# TWIN LAKES

**STAFF REPORT  
DEVELOPMENT COMMISSION  
ZONING MEETING  
CITY OF COLUMBUS, OHIO  
MAY 13, 2004**

- 16. APPLICATION: Z03-062**
- Location:** **6787 LOCKBOURNE ROAD (43137)**, being 143.24± acres located on the west side of Lockbourne Road, 1550± feet south of London-Groveport Road. (010-261378)

**Twin Lakes (Z03-062) Review for 6.22.04 Submission:**

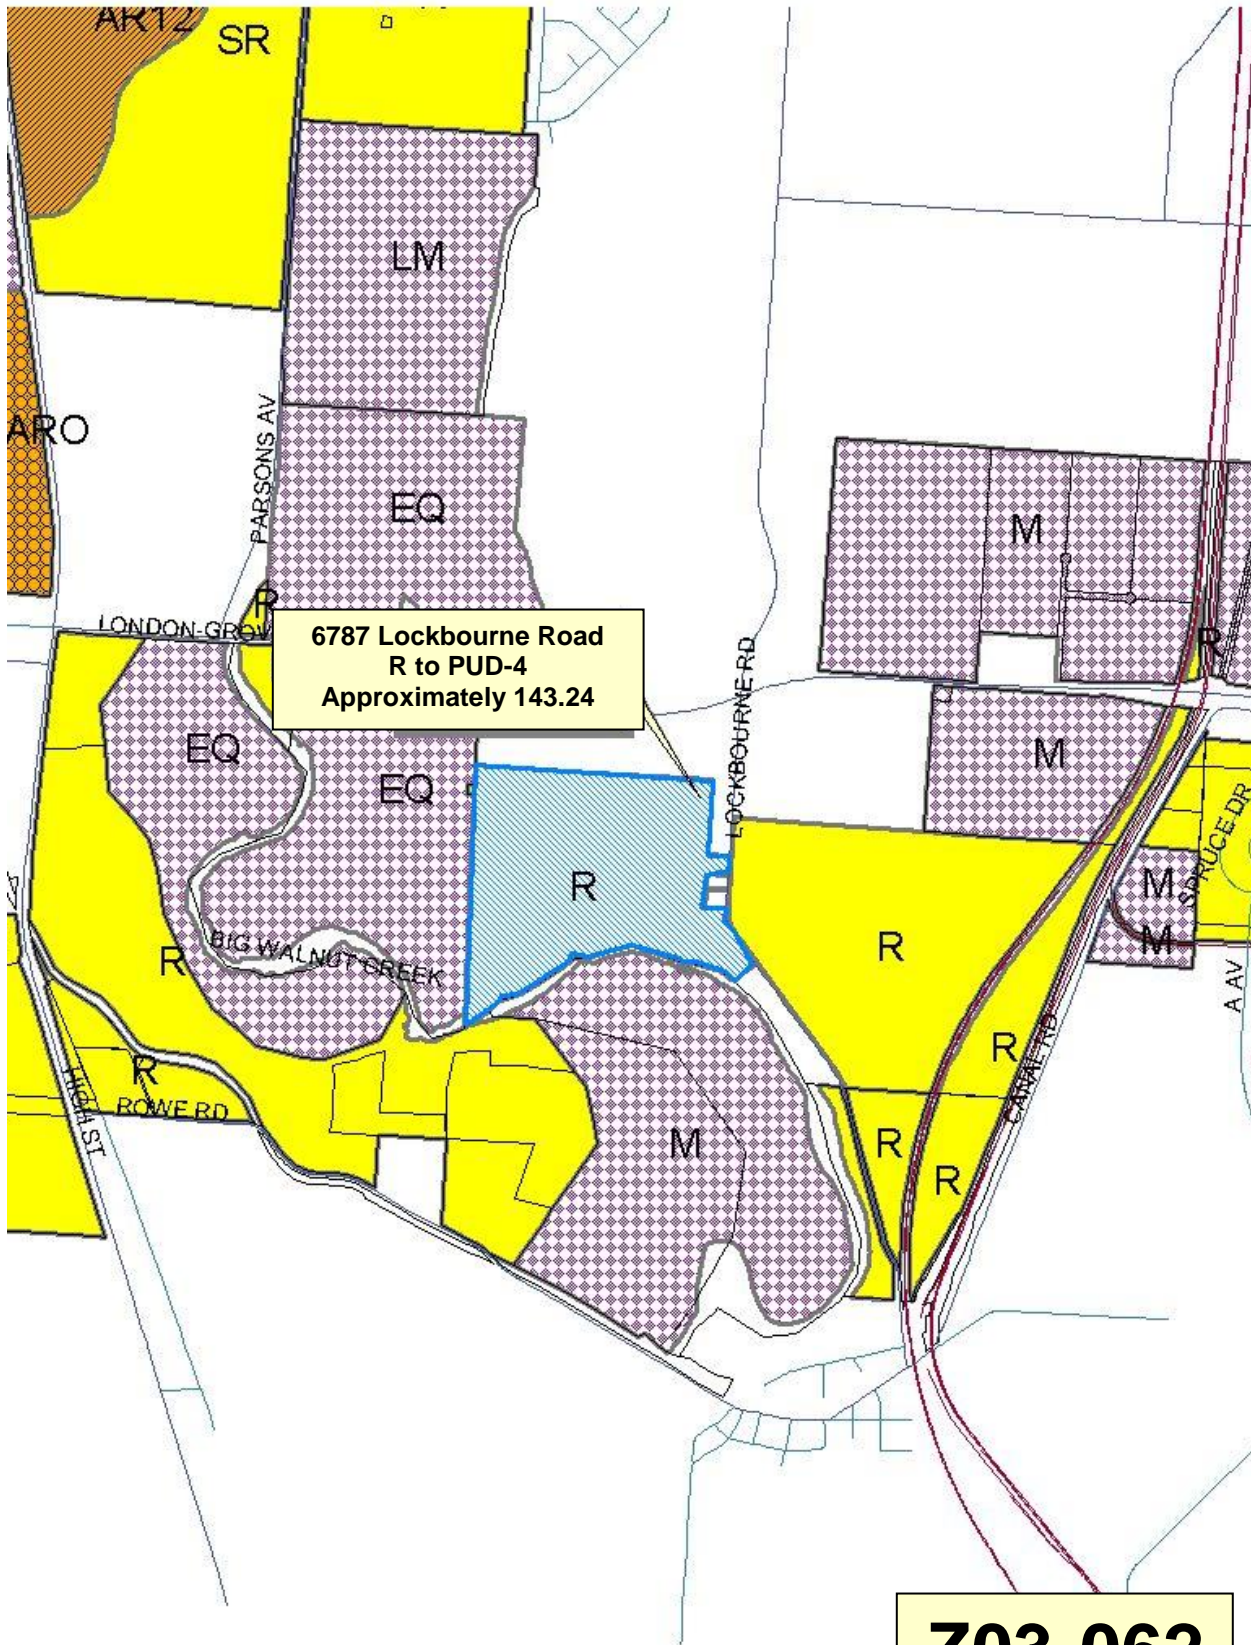
- Lot number eighty-two is within the required setback for homes that do not front Lockbourne Road.
- Condominiums along the western property line are located within the 100' required buffer between residential and industrial uses.
- The central focus of this neighborhood is the quarry lake. A large number of homes back to the quarry lake. The excessive number of lots backing to the pond erodes and weakens the development's ability to meet this checklist item.

The submitted plan does not meet the plan's recommendations for setbacks along Lockbourne Road, setbacks from industrial uses, and centralized open space with a number of single-family lots backing on to the lake.
